ADDENDUM #2 – APRIL 2, 2025

RE: CITY OF COQUILLE URA
N. Adams Street Improvements Phase 1: Underground Improvements
Project #23.81

FROM: HGE ARCHITECTS, Inc.
333 South 4th Street
Coos Bay, Oregon 97420
541-269-1166

SHEET TITLE:
SANITARY SEWER -
STA 19+50 - 21+00 &
STA 30+00 - 31+75

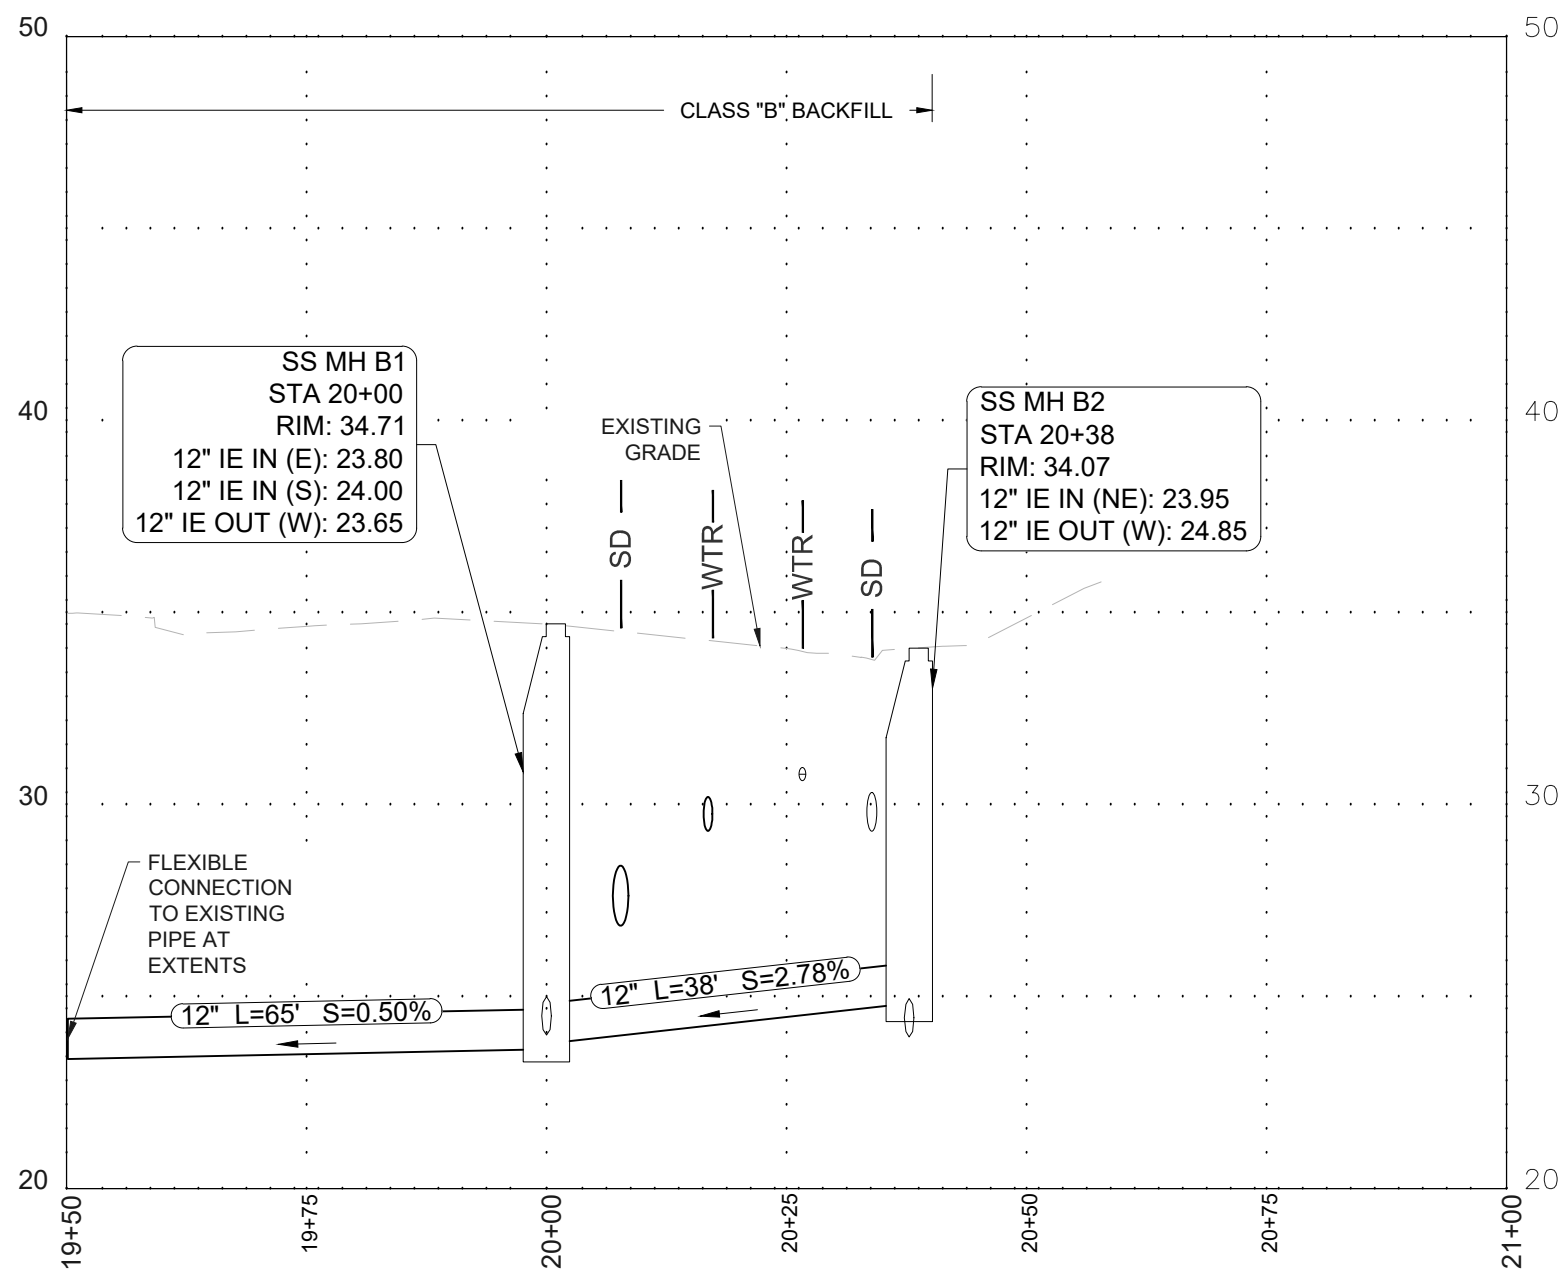
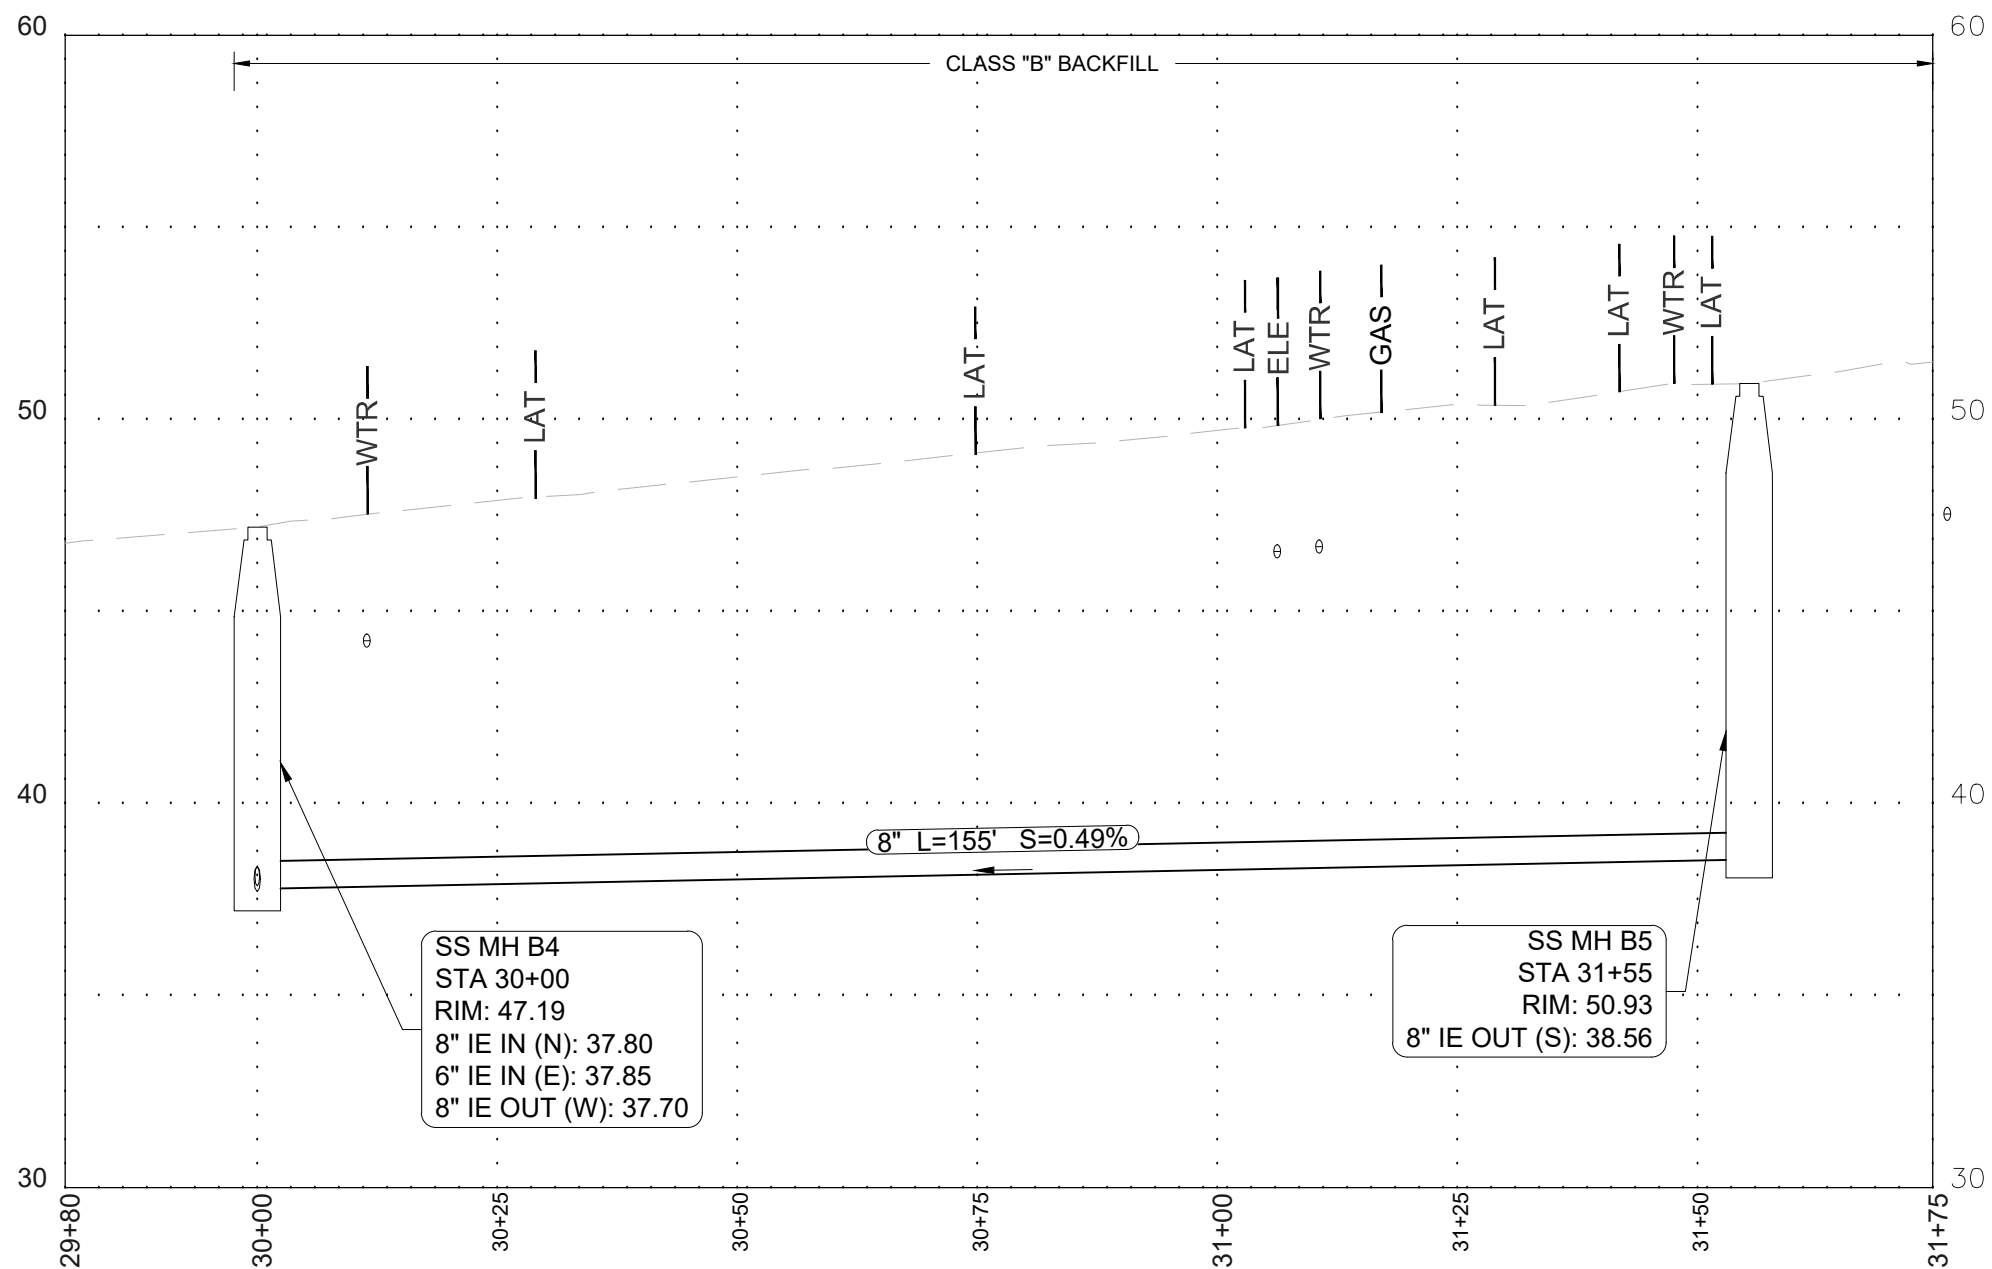
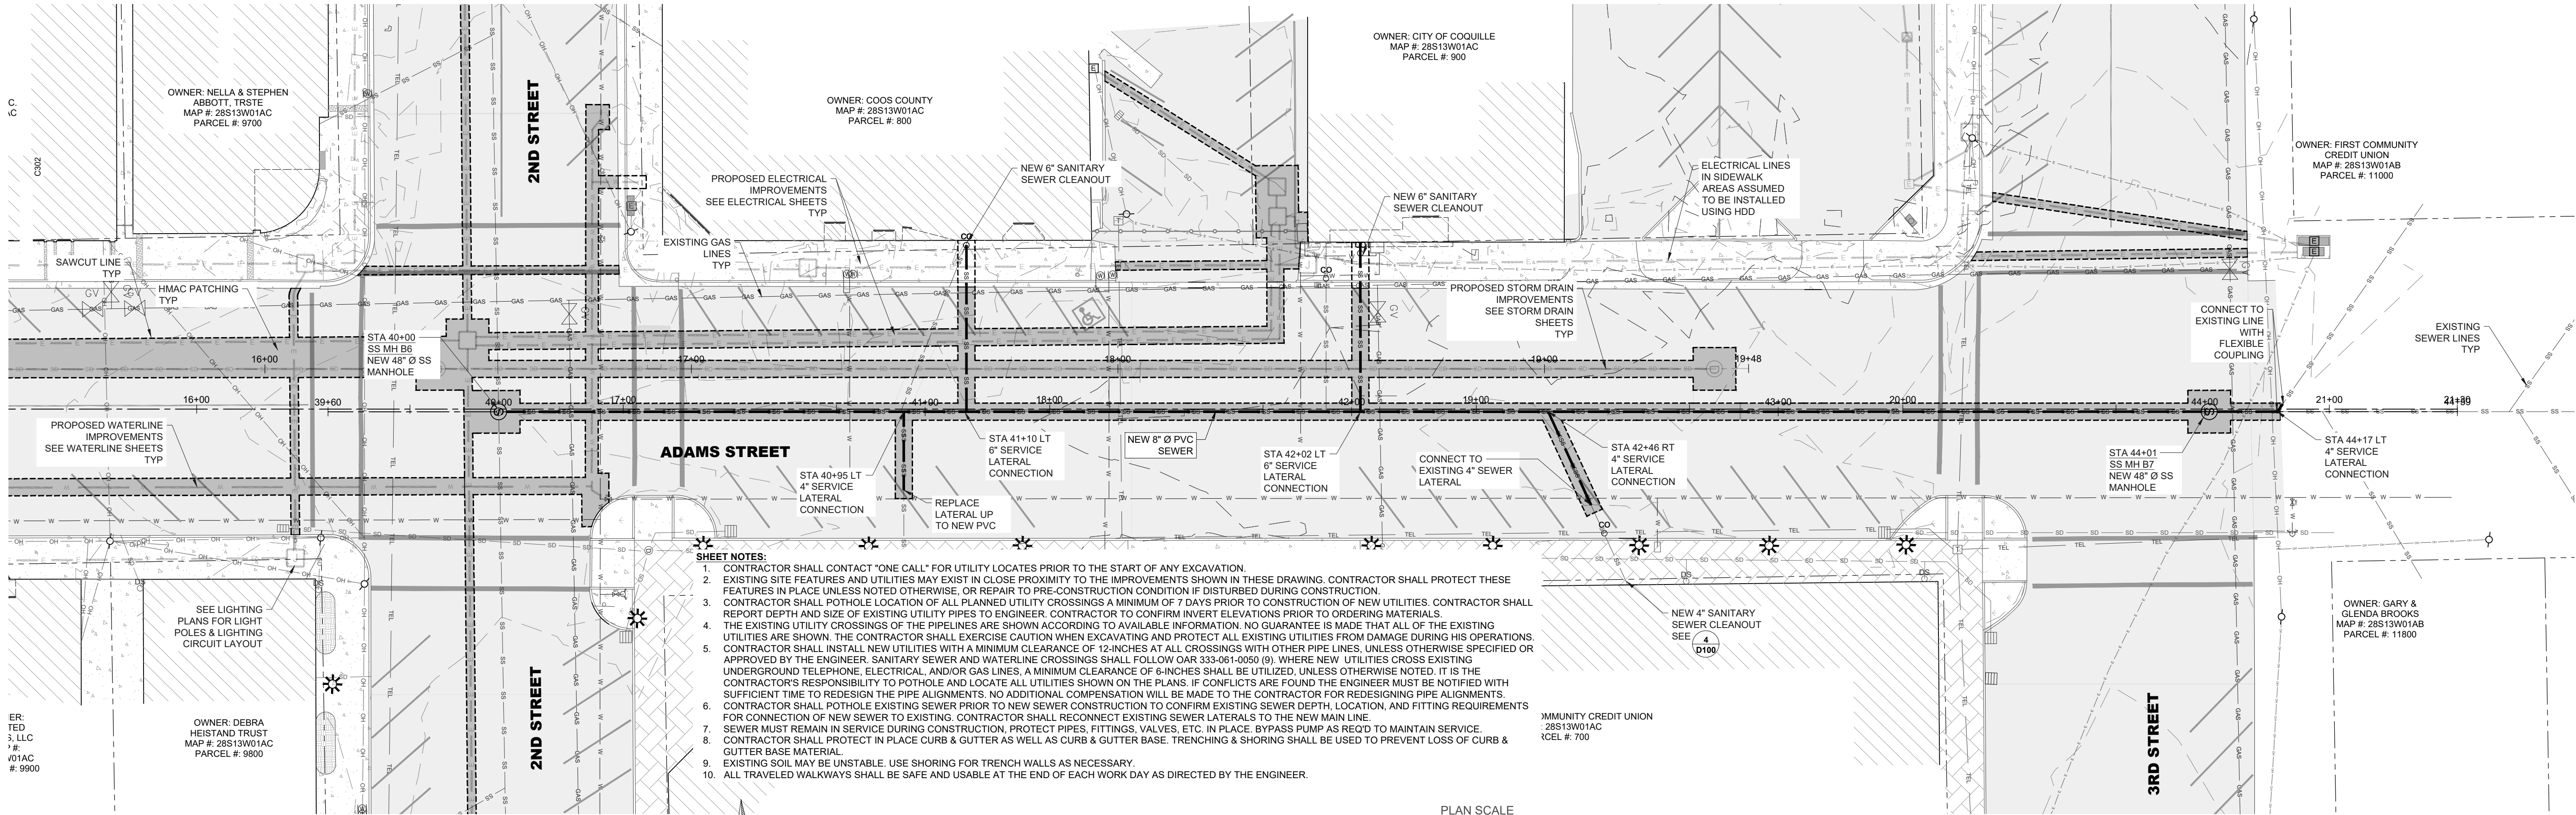
1. **Sheet C200 Sanitary Sewer – STA 19+50 – 20+00 & STA 30+00 – 31+75:** REPLACE sheet with attached revised sheet.
 - a. **Revision Summary:**
 - i. Added note to connect 8" lined pipe at STA 30+00 manhole

- ii. Deleted a note pointing to nothing
 - iii. Corrected lateral at STA 31+10 or so to 6" from 4"
2. **Sheet C201 Sanitary Sewer – STA 40+00 – 44+59:** REPLACE sheet with attached revised sheet.
